EASTERN CORRIDOR SEGMENTS II AND III (PID 86462)

COMBINED LINWOOD/EASTERN INTERCHANGE & US 50/RED BANK INTERCHANGE FOCUS AREAS ADVISORY COMMITTEE MEETING NOTES

February 14, 2018
May 22, 2018
September 7, 2018
December 12, 2018

Figure X-2B-2
GRADE SEPARATED INTERCHANGE TO CONNECT
WILMER AVENUE TO WOOSTER ROAD

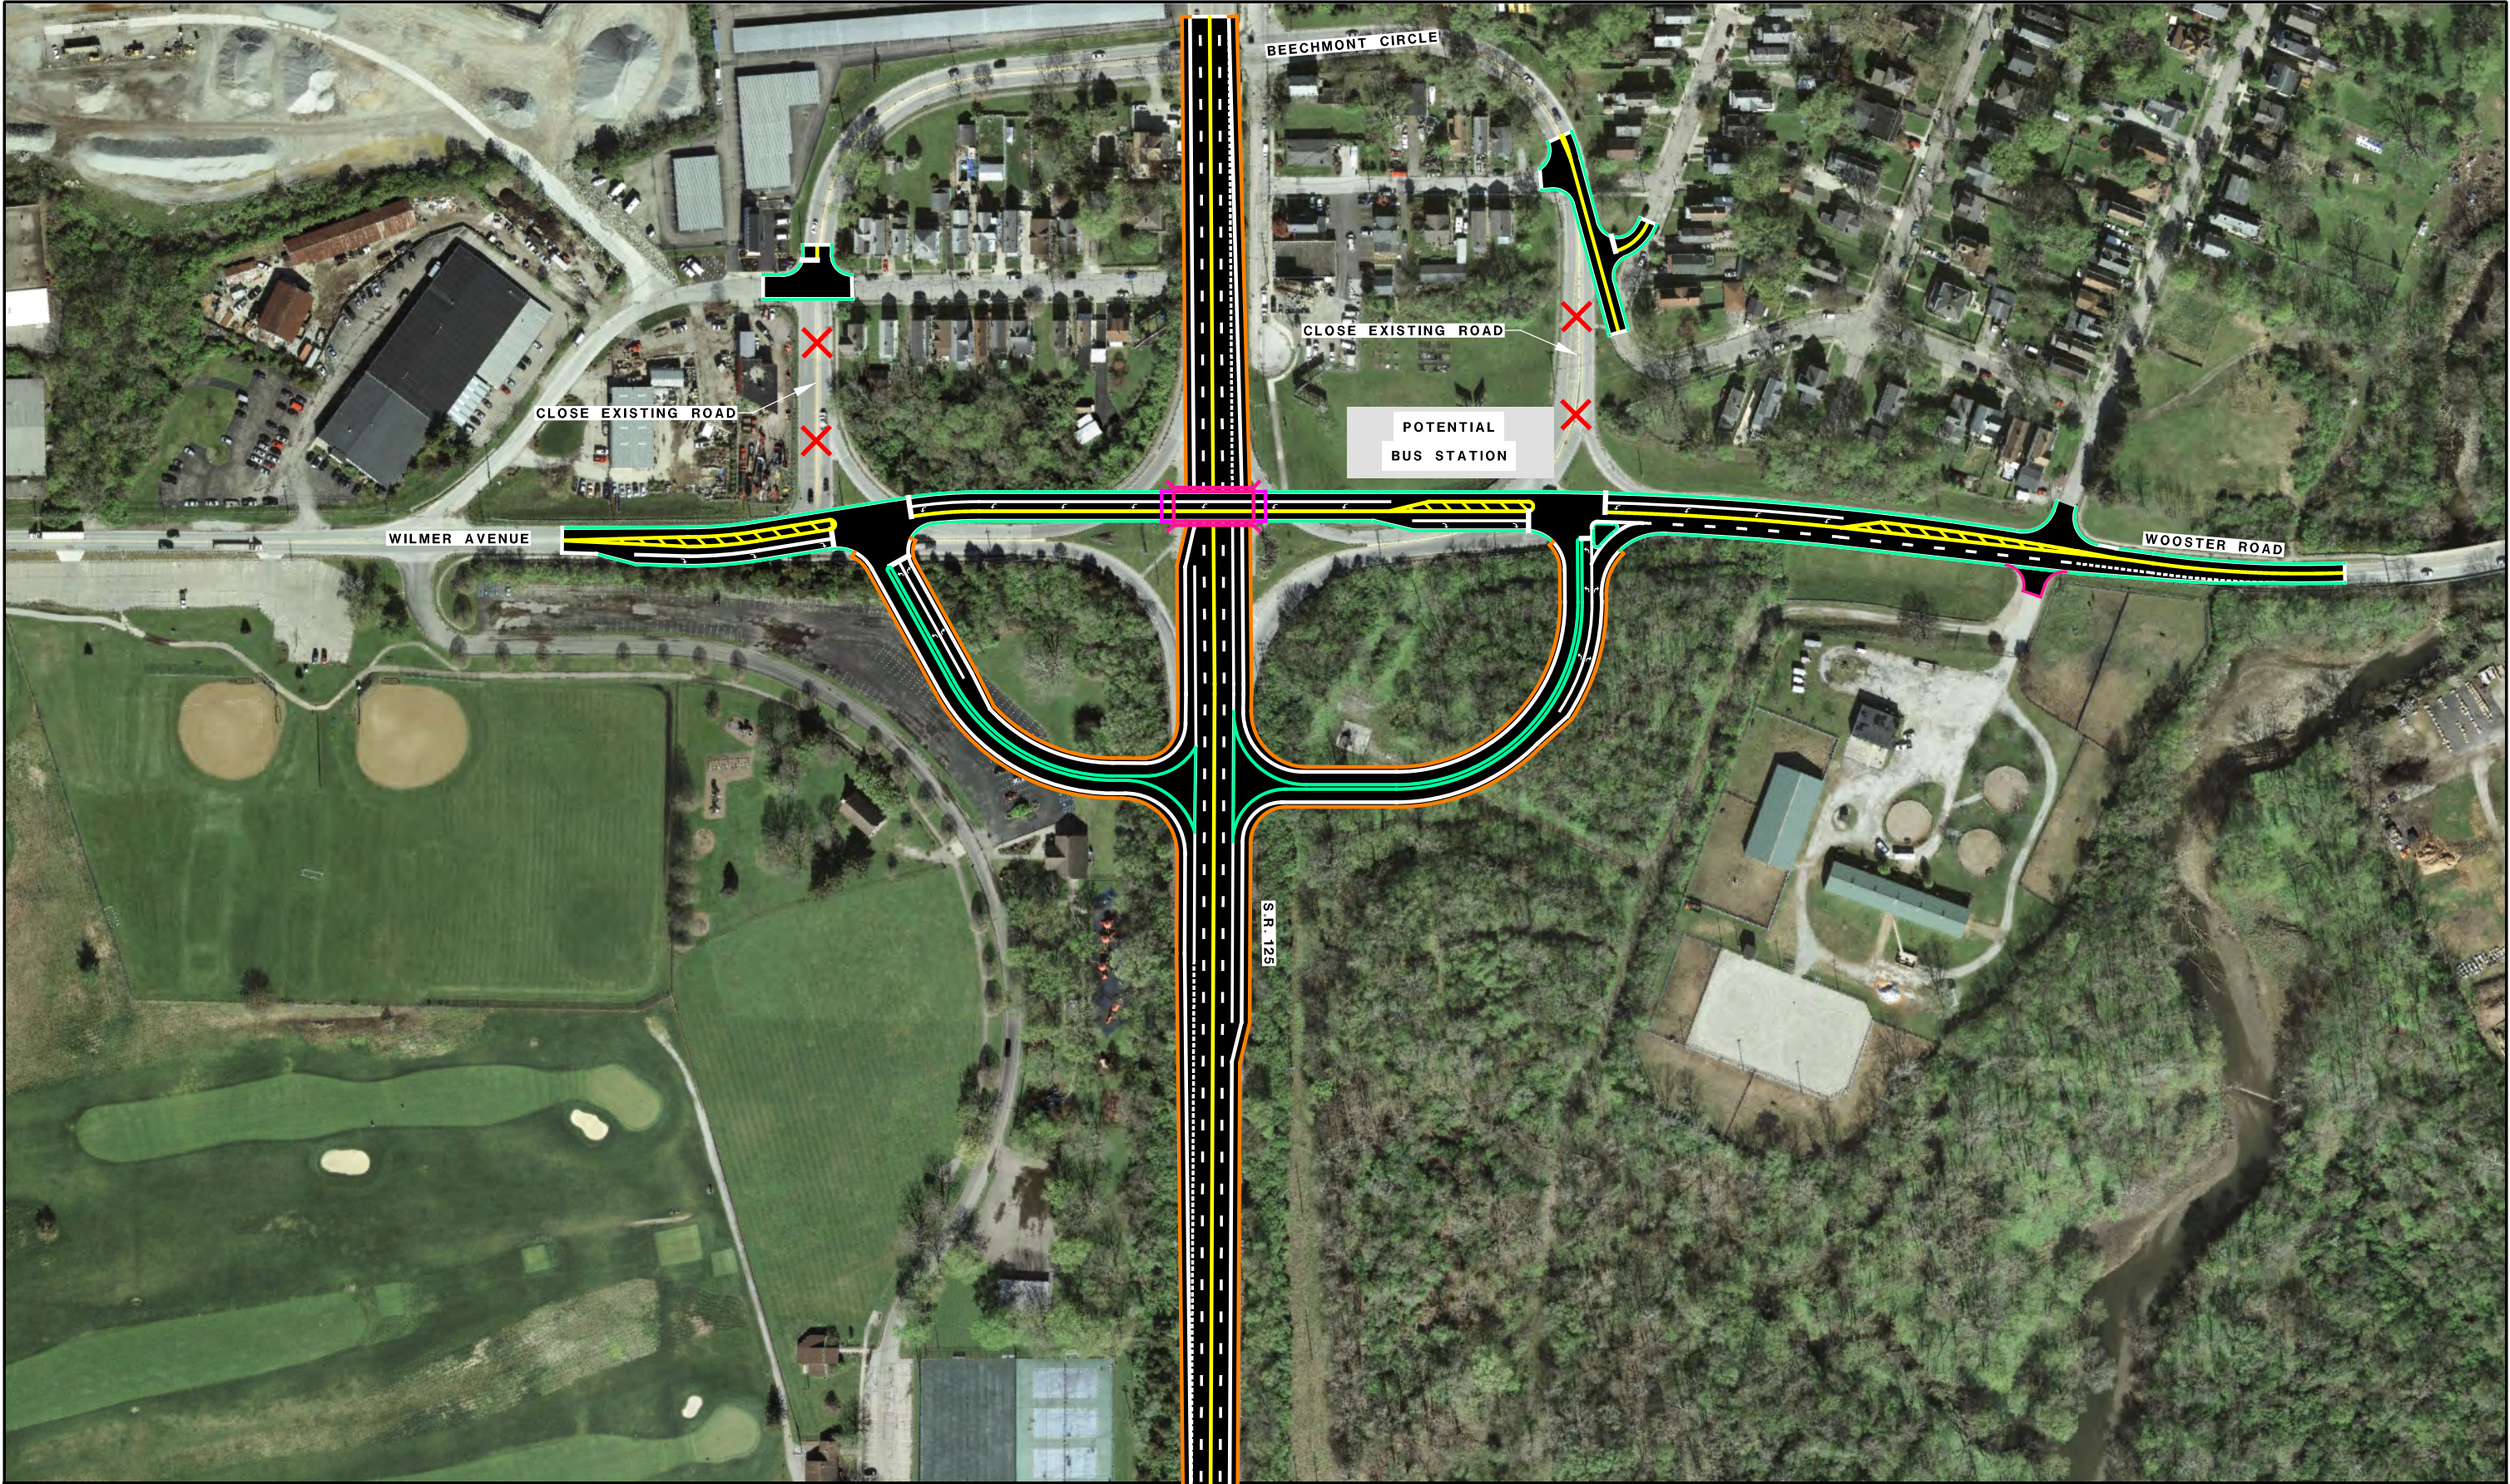
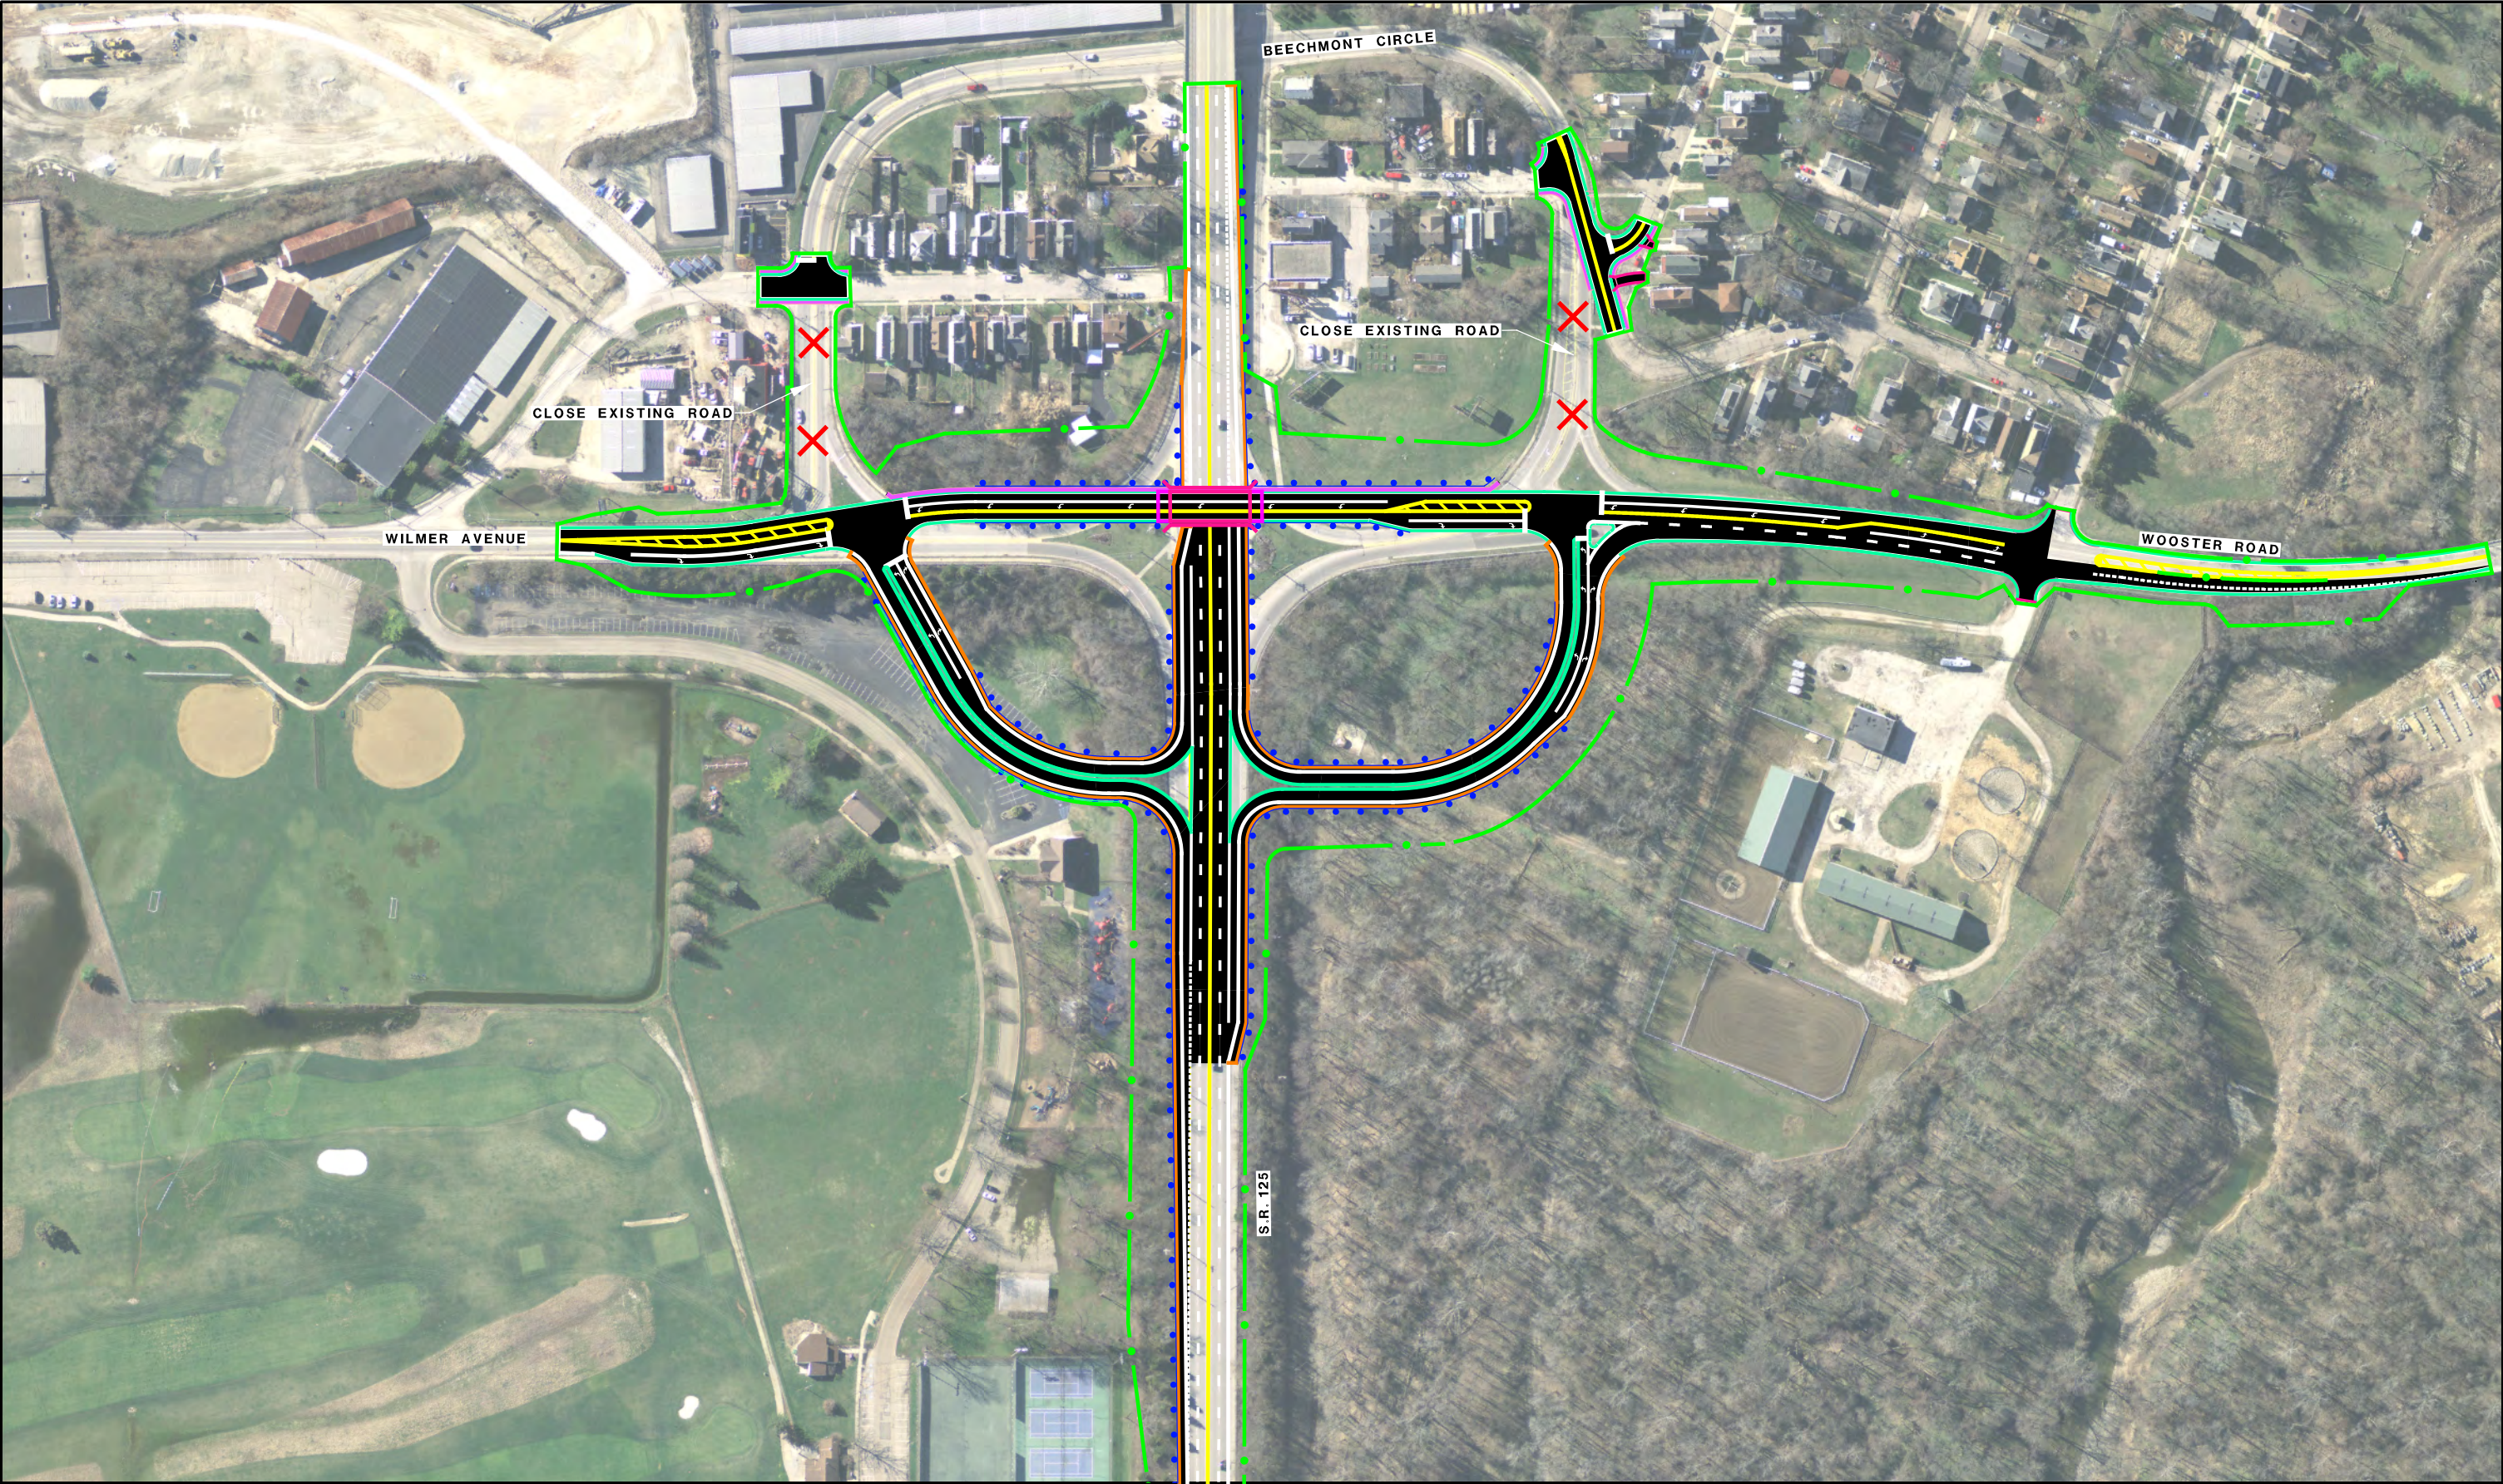
- This concept offers a lower speed connection to Wilmer Avenue and Wooster as compared to concept X-2b-3.
- The Wooster/Wilmer interchange would bridge over SR 125.
- Offers a clear connection between Wilmer and Wooster.
- Concept would take through-traffic off Beechmont Circle; streets within Beechmont Circle would be used for local traffic.
- Would need to add a turn lane to Hutton Street from Wooster.
- Concept would impact the locations of existing bus stops; bus stops would have to be relocated.

- Comments Submitted Following the 5/22 Meeting**
(Comments are presented as submitted by Committee members; no edits to content were made.)
- Will the three-way intersections on either side (East and West) of the proposed grade change connection of Wilmer and Wooster be signalized, or stop signs? Concern this will slow flow of traffic compared to current design.

- ODOT Response:
- The intersections would either be signalized intersections or reconfigured into roundabouts.
